Origination Form
Proposed Revisions to a Standard Plans Index

Originator:	Pinkham, Andrew	Index Number:	430-030
Date:	6/3/2025	Sheet Number(s):	2
E-mail:	andrew.pinkham@dot.state.fl.us	Index Title:	Straight Concrete Endwalls Single and Multiple Pipe

Sheet 2: Added DETAIL "B" to show Option I or II.

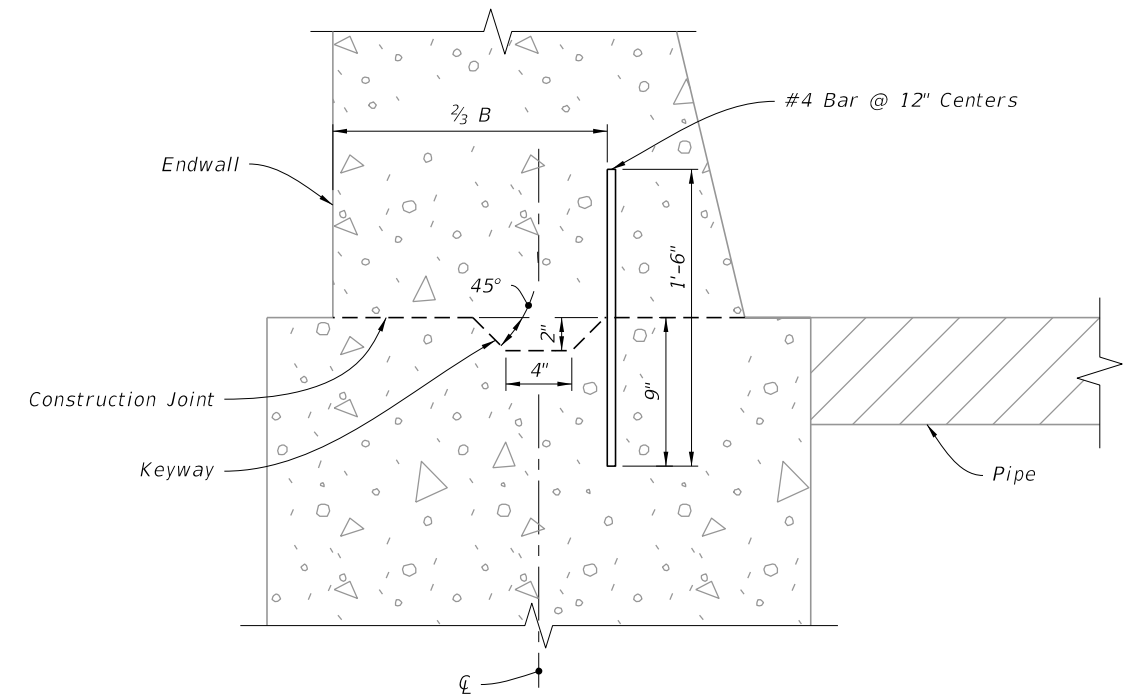
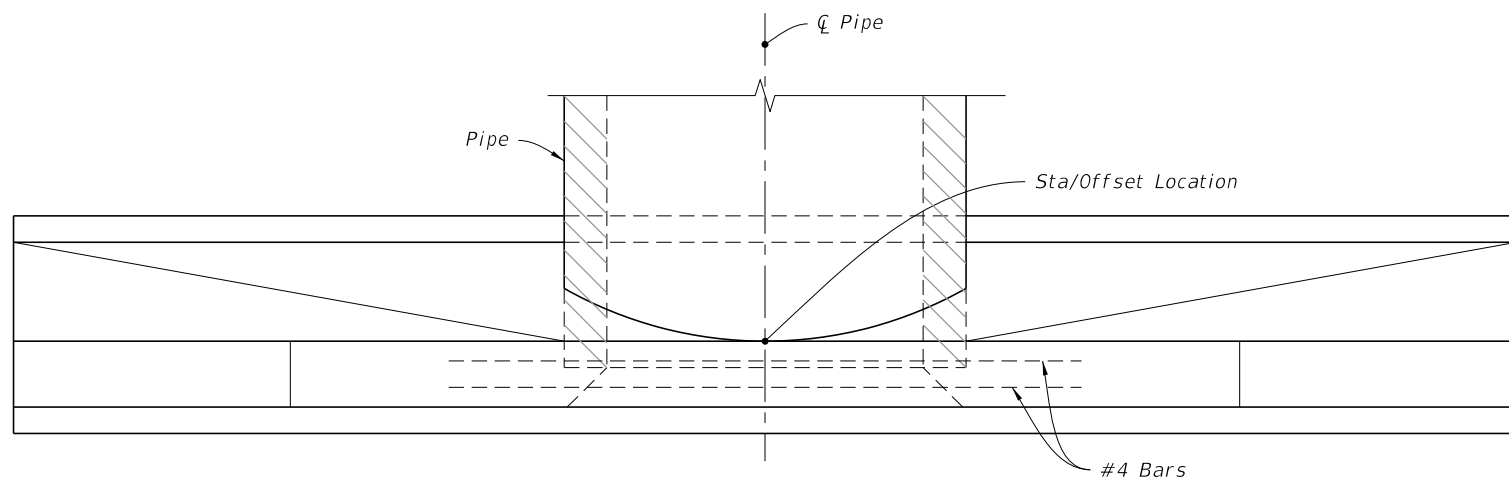
Addition of alternate to hole forming details and minimum beam height above the opening. Issues with delivered product and at request of Industry. Request came through the Precast Concrete Structures Association to Andrew Pinkham at SMO, through Drainage Design and was signed as an Approved Shop Drawing by State Drainage Engineer.

SHEET
2 of 4

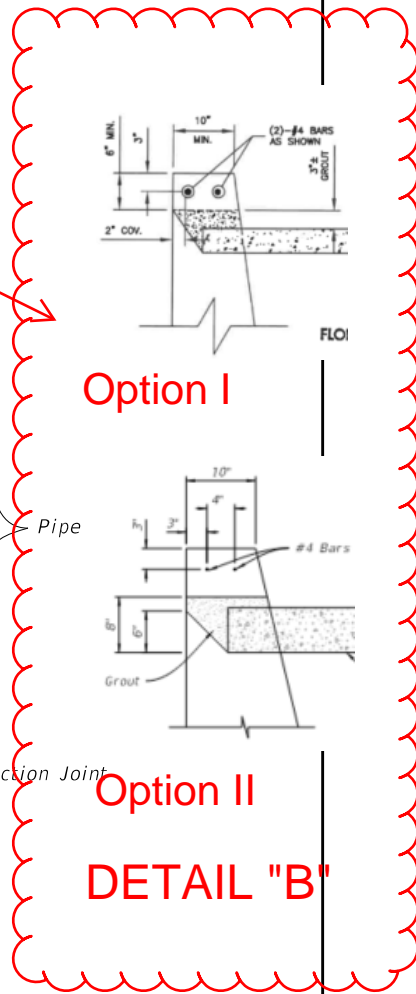
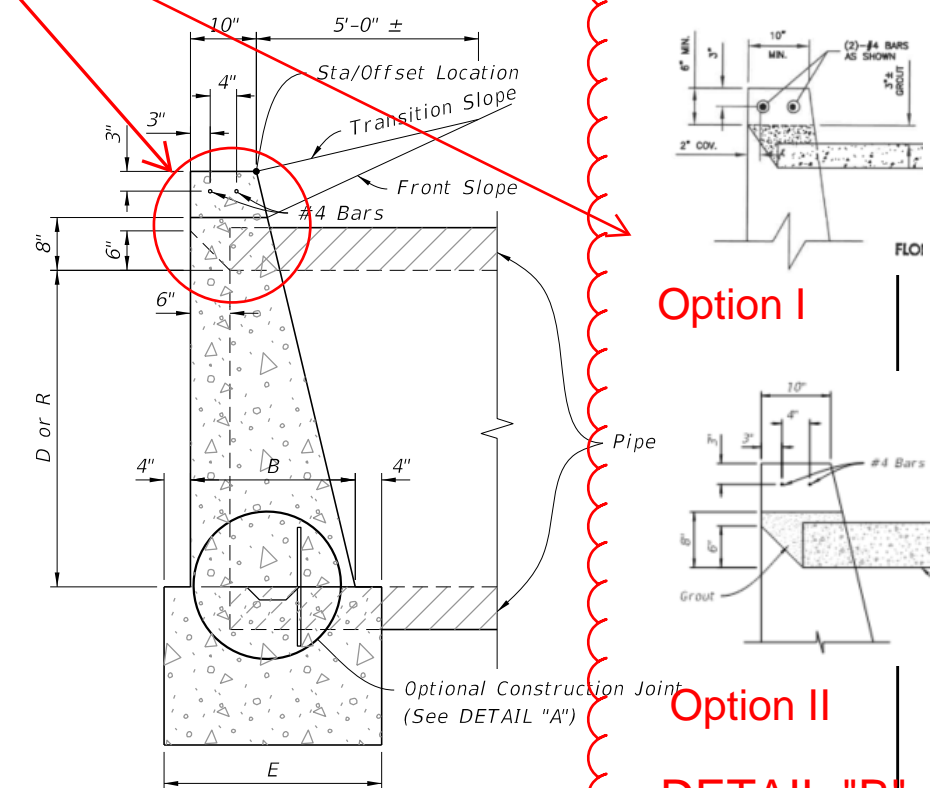
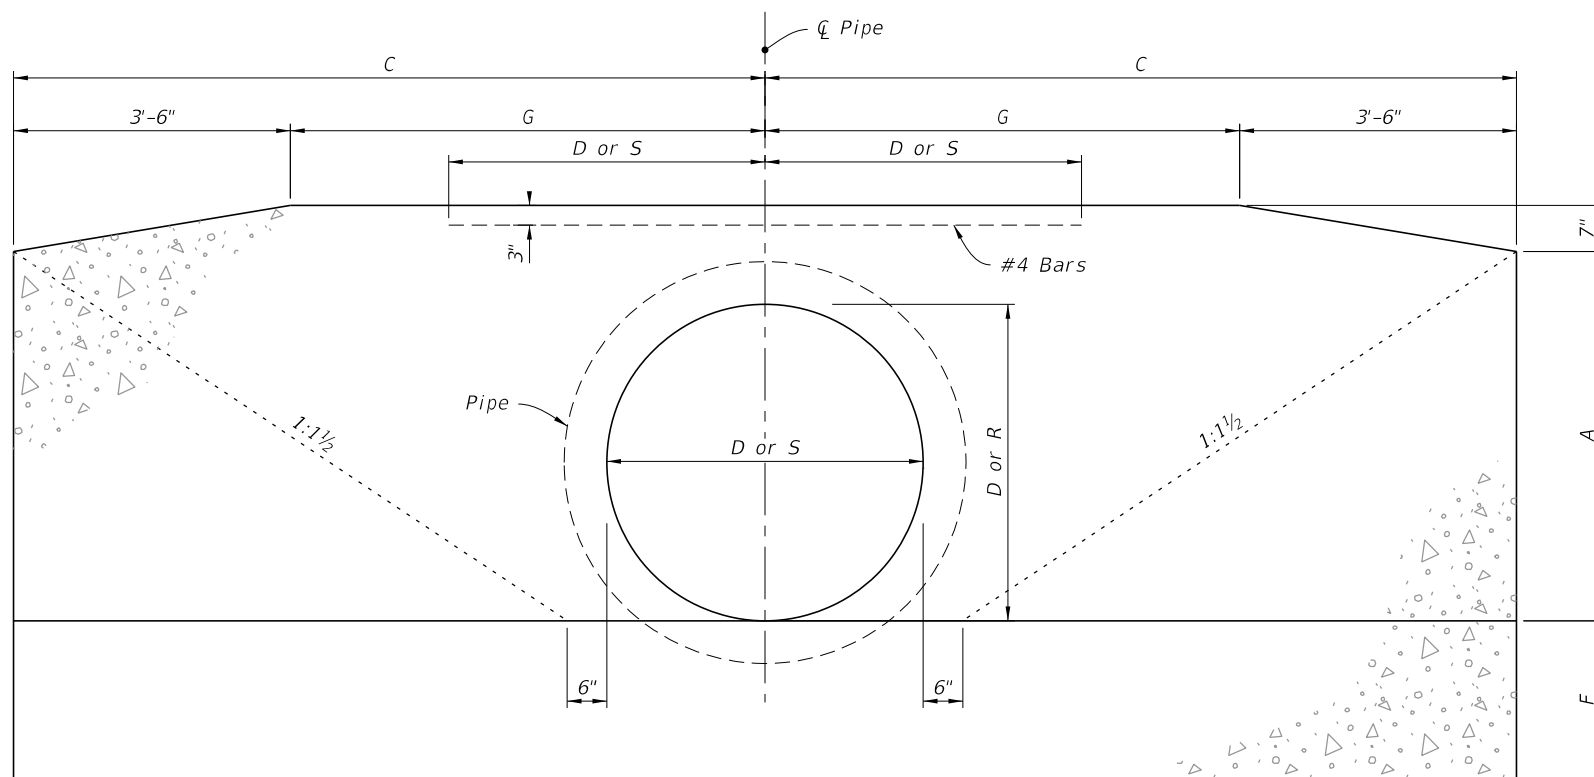
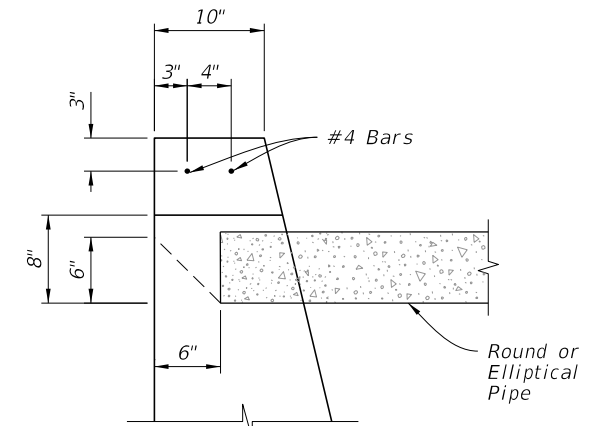
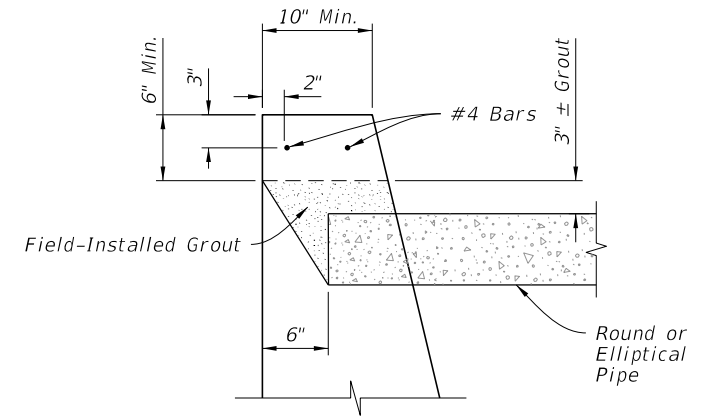
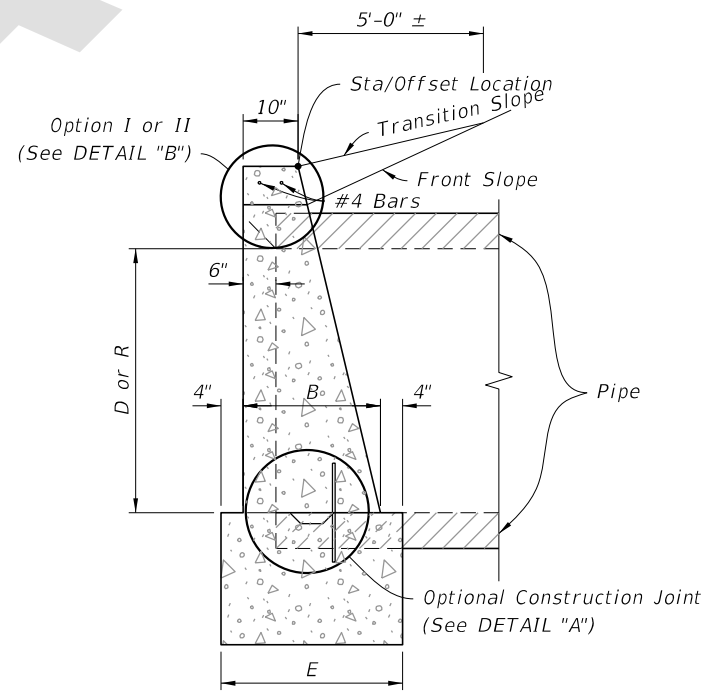
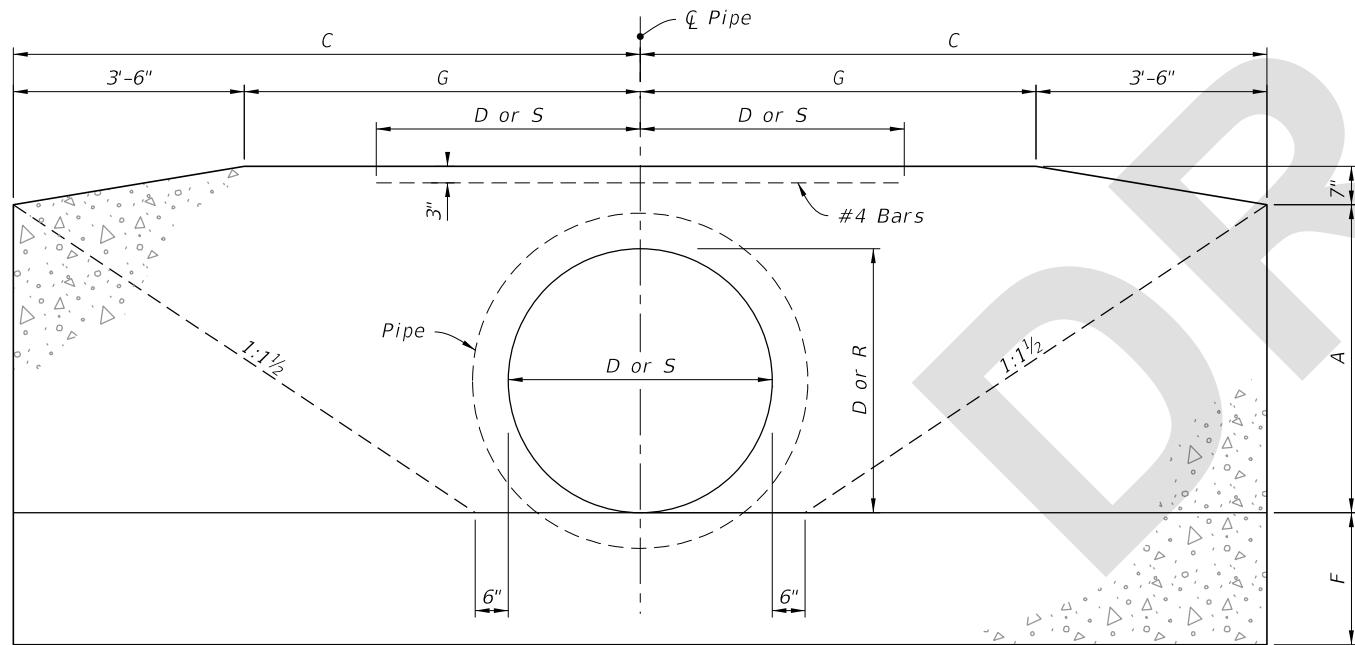
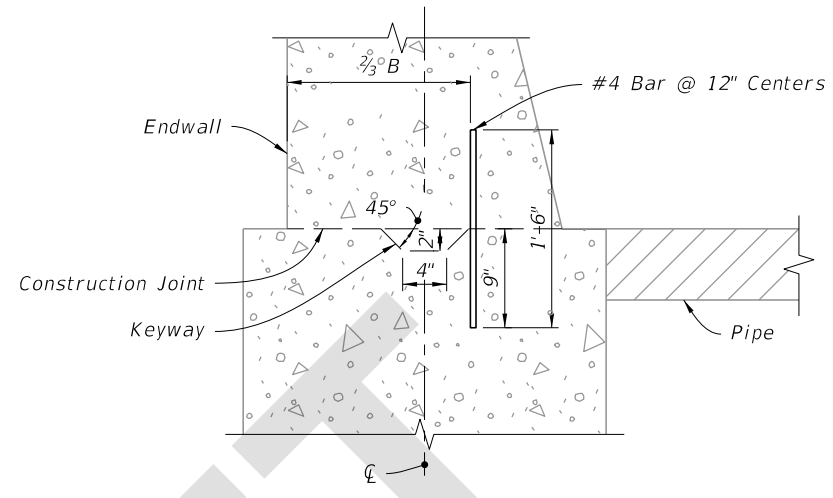
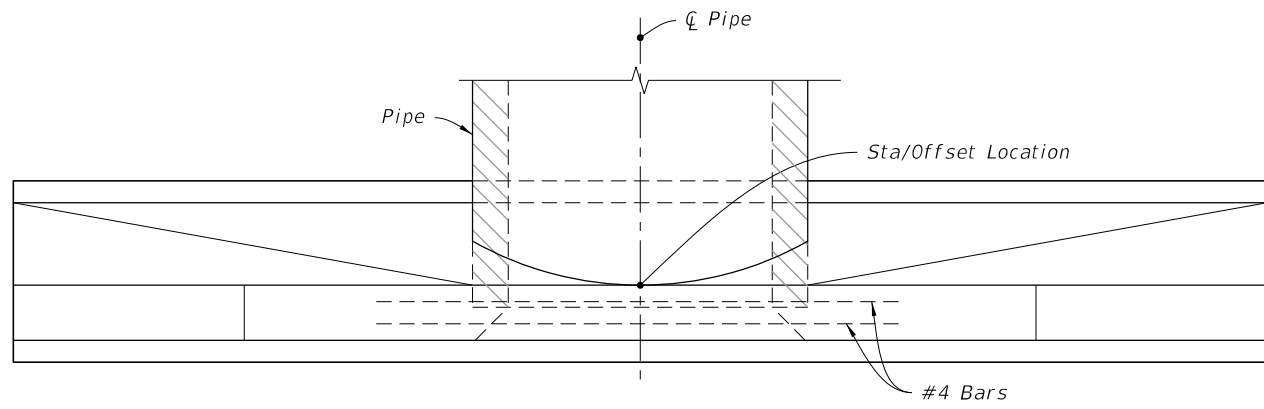
ADDED:
DETAIL "B" to show
Option I or II

DETAIL "B"

NOTE: Keyway and Dowels are required for optional construction joint.
